Middleton Planning & Zoning Commission

Findings of Facts, Conclusions of Law, and Recommendation

In the Matter of the Request of Wade Thomas of IAG Capital, LLC and Unger Enterprises for preliminary plat with respect to The Mill at Middleton Subdivision located at 0 N. Dewey Avenue (Tax Parcel Nos. 33892, 33888, and 33876):

The Mill at Middleton Subdivision

PRELIMINARY PLAT SHOWING
THE MILL AT MIDDLETON SUBDIVISION

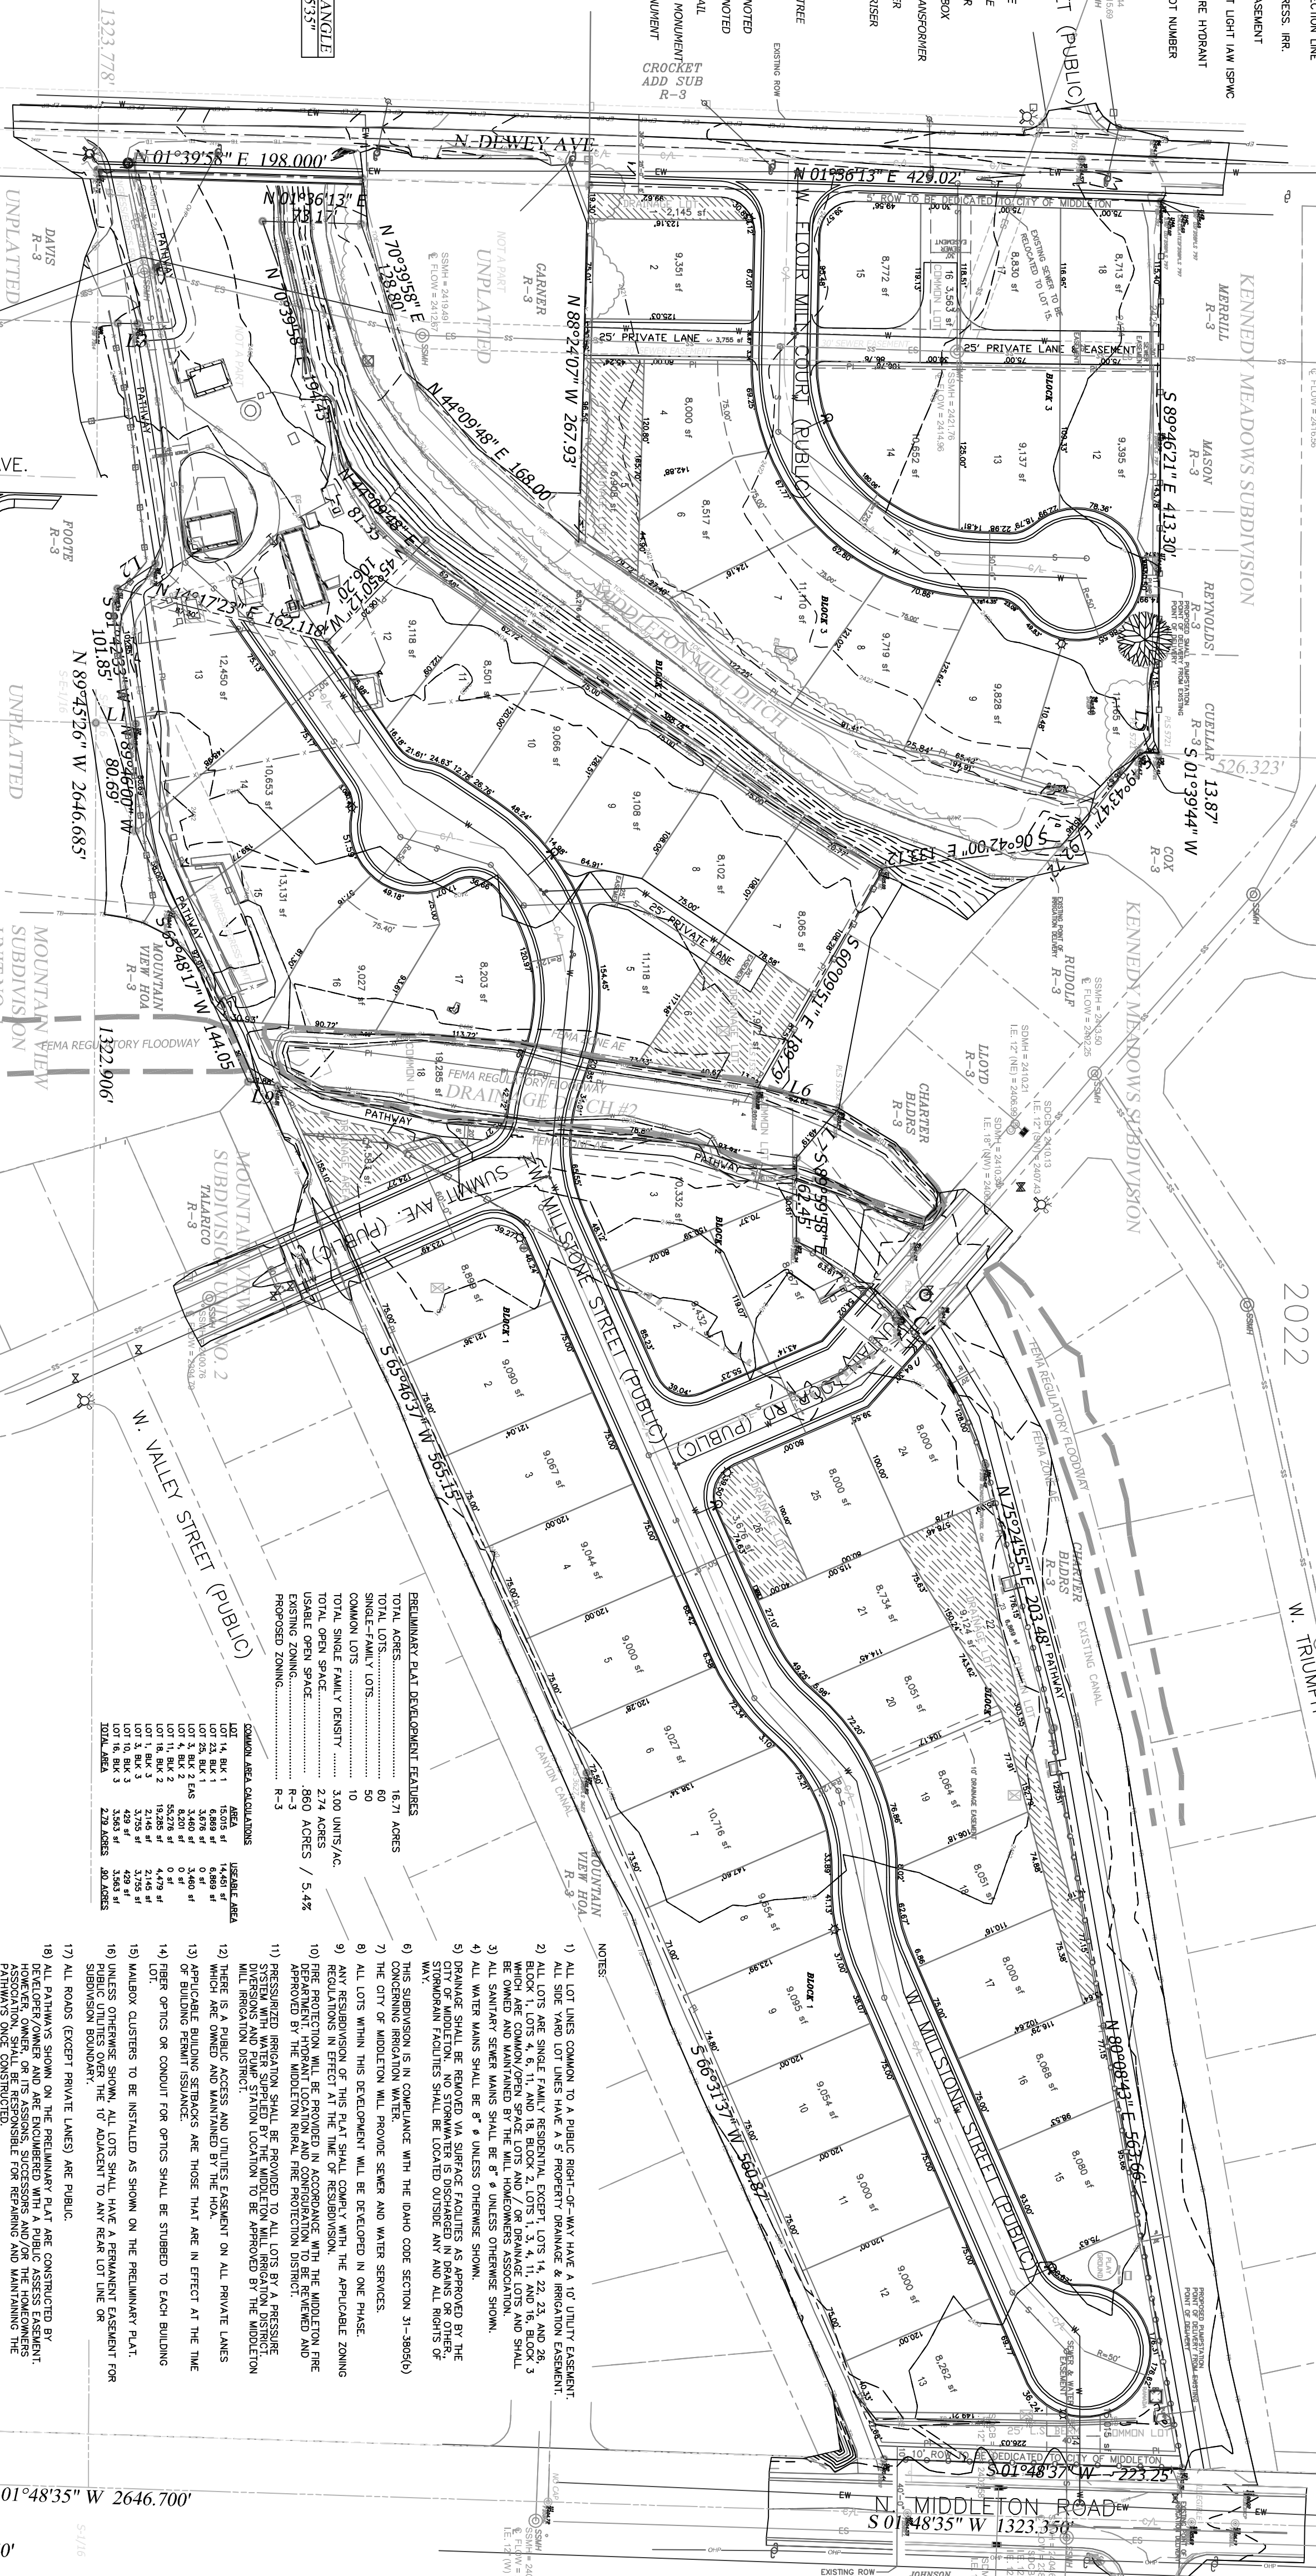
MCC 5-4-4.2. a. Please add bearing and distance to section corner, quarter corner or monument of record.

MCC 5-4-4.2. c. Adding phasing plan if applicable or note all lots developed in one phase.

MCC 5-4-4.2. f. Revise topography to clearly show existing.

1. Either eliminate lines (assumed existing) or label.
2. Dimension and clearly identify every lot.
3. Please use 2ft contours and label them.
4. Add benchmark information.

1. Show Canyon Canal along the south boundary, including topography.
2. Show existing irrigation infrastructure for parcels and relocation if applicable.

1. Dimension existing rights of way and clearly label/name.
2. Show improvements on Dewey clearly and how proposed frontage area will transition to existing. Include stormwater management.
3. Dimension right of way for Dewey.
4. Show existing easements including for "Existing Canal Drainage Ditch #2" and Middleton Mill.
5. Add note or callout power in Dewey to be relocated.
6. Show Minot Street intersection and label.
7. Mountain Loop Road (not legible) right of way to be consistent to the intersection with Millstone Drive.
8. Is the sewer easement 30ft or 20ft? Show the easement.
9. Label Middleton Road right of way and additional width to be dedicated.

10. What is the ownership of the private lanes? If separate lot, label accordingly. If easement area then also dimension and clarify.

1. Add a note addressing installation of fiber optic network.
2. Add note hydrant location and configuration to be reviewed and approved by Middleton Rural Fire Protection District.

1. Review the sewer crossing at Summit (profile) and verify there is sufficient depth and separation from the bottom of the canal per the irrigation or drainage district with jurisdiction.
2. What is the purpose of new 20ft sewer easement between lot 16 and lot 14, block 3.

3. Water corridor is north and east, sewer is south and west.
4. Please plan to connect to the existing water main at the intersection of Middleton Road, at Summit and at Mountain Loop.
5. Connect to Middleton water main at 90d and add three valves.
6. Show the existing water in all streets and in private lanes. How will utilities be extended to lots and is there separation per IDAPA?

1. Stormwater. Plan to manage a 100 year/1 hour storm using retention facilities only. No subsurface. The front half of the lot C value is 0.60, the rights of way/impervious (all) are 0.95 – use a composite of both. All stormwater management facilities require pretreatment, all infrastructure to be shown on preliminary plat. Stormwater facilities are owned by HOA and the provisions for maintenance laid out in CCRs. Identify lots to be used for stormwater management
2. Note 5. No discharge of stormwater from rights of way.

Add note detailing all irrigation and/or drainage to be relocated out of rights of way.

Note 6. Expand to address Idaho Code 31-3805(b). Show the irrigation system layout and point of diversion/pump station location. Combine with Note 11.

Note 7. City of Middleton will provide sewer and water service.

Note 8. Delete

Note 12. Add public utility to the easement purpose.

Note 19 and Note 20. Delete.

Add a note regarding fiber.

Add a note: exterior boundary is required to be fenced in accordance with approved fencing plan. Remove perimeter fence callout or add it to the landscape plan.

Correct street names. Street is east/west. Avenue is north/south. Cul-de-sac is Court.

Add centerline radii and intersection radii.

2nd Round Planner Comments The Mill Subdivision (Pre-Plat dated 12/29/2021) January 5, 2022

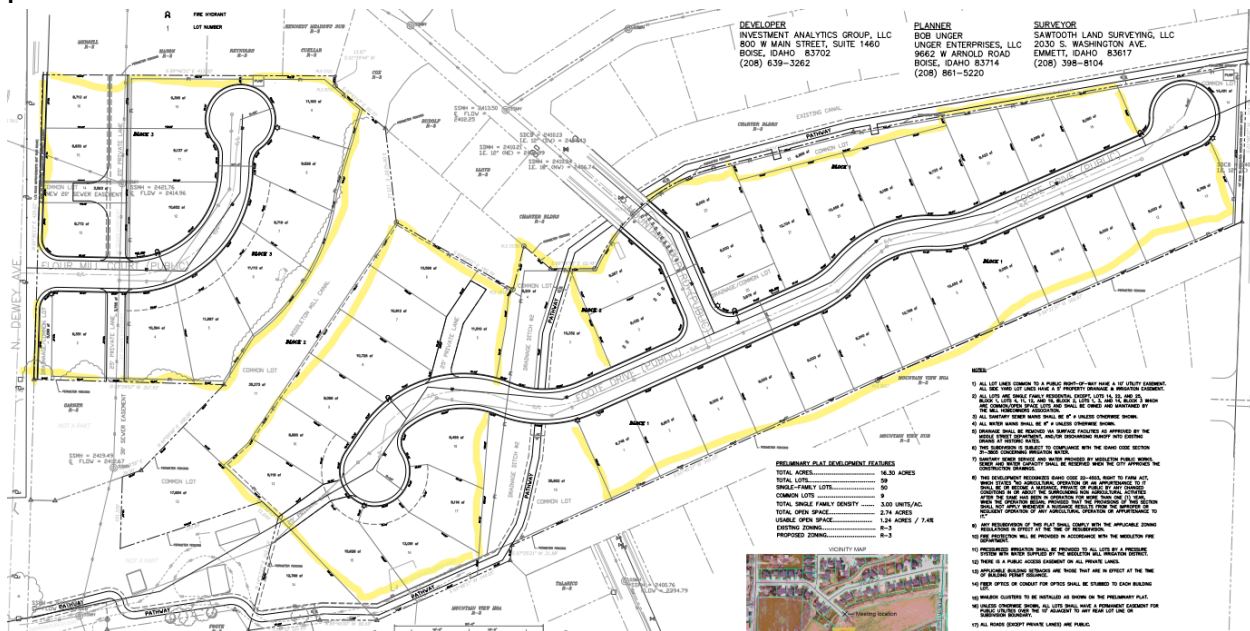
1. City will take care of 2 non-conforming lots to the north, and it is no longer a problem for this development.
2. Talk with HOA that owns Summit Road section over Canal to determine best way to get road completed over Canal.

3. Add a lot and block designation to the common lot south of Foote Drive where the Drainage Ditch #2 is located. It probably should be Lot 19/Block 2. Then change the other Lot 19/Block 2 to Lot 20/Block 2.

4. Change the name of Foote Drive to another name not on the County's road list. Foote Avenue already exists.
5. Middleton Road requires a 24' landscape buffer "easement" along the frontage per 5-4-10-4. Just call out the easement and show it on the Landscape plan.

9. What amenities are you going to provide? Please show designations on the pre-plat. It would be nice to have benches in common areas along pathway.
- 10.

3rd Round Planner Comments The Mill Subdivision (Pre-Plat dated 1/5/2022) January 12, 2022

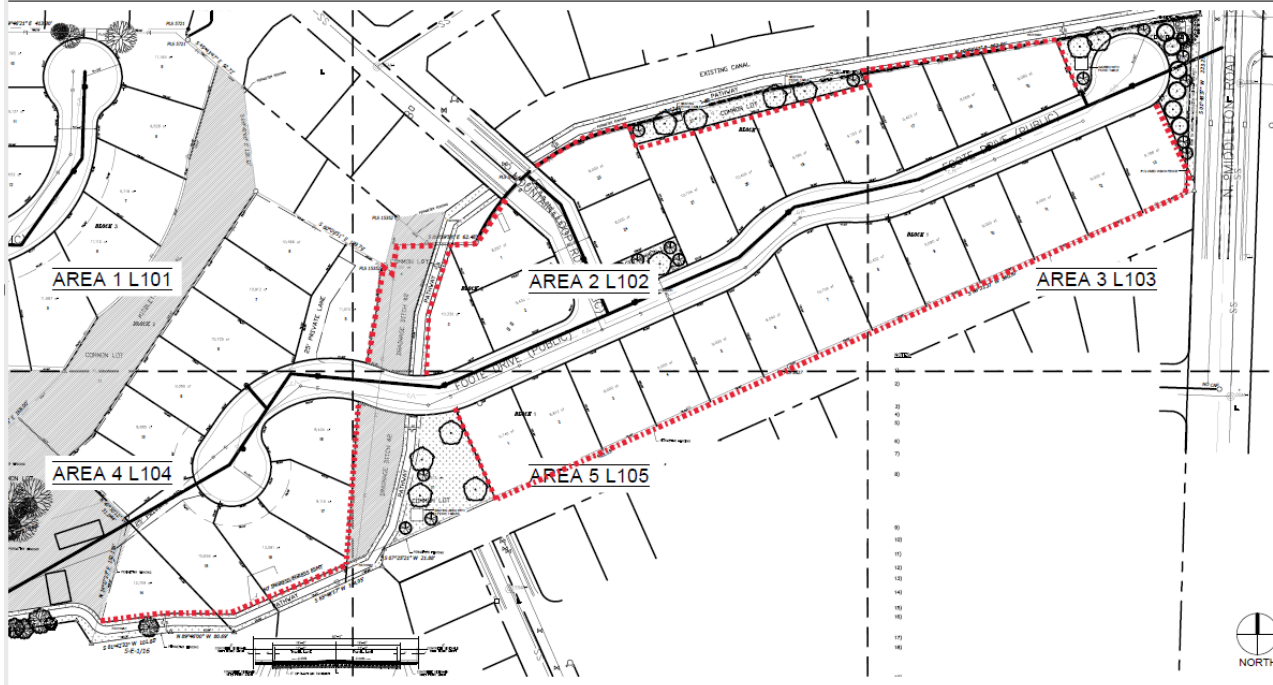
1. Amy W., noted that you need a variance for the cul-de-sac length exceeding 600'. We are allowed to handle variances as "waivers" to the code during the pre-plat process (MCC 1-15-2), and you will not need to physically submit a variance. BUT, please add a note to the Preliminary Plat that there is a variance to exceed the cul-de-sac length found in MCC 5-4-10-2.
2. Please change note 12 to add language that all Private Lanes are owned and maintained by the HOA. .
3. As Amy requested, please remove the perimeter fence call-outs from the pre-plat, but we need you to show the fencing on the landscape plan. Also, add a note to the preliminary plat as follows:
"Variance to allow subdivision perimeter fencing along rear boundary of residential lots adjacent to open space rather than on subdivision perimeter boundary. Subdivision fencing shown on accompanying Landscape Plan."

Please do not put the perimeter fencing on all of the subdivision perimeter boundary because it will unnaturally enclose open space/common lots. Please show "perimeter" fencing around common lots as shown below. Except you might prefer to fence in the canal for safety reasons. If you do, please consider wrought iron fencing along the canal so the pathway seems open, walkers can enjoy seeing the water, but children will not be endangered. Site plan below generally shows that wherever common open space is present, the fencing should end at the boundary of adjacent residential lots and not enclose the common area.

4. The revised lot line adjustment looks accurate to me, but I still need to get Amy's opinion on it. If she approves the lot line documents, we will need to make it a condition of pre-plat approval that the lot line adjustment will be finalized before initial submittal of construction documents.

5. change features table to note that there are 10 common lots.
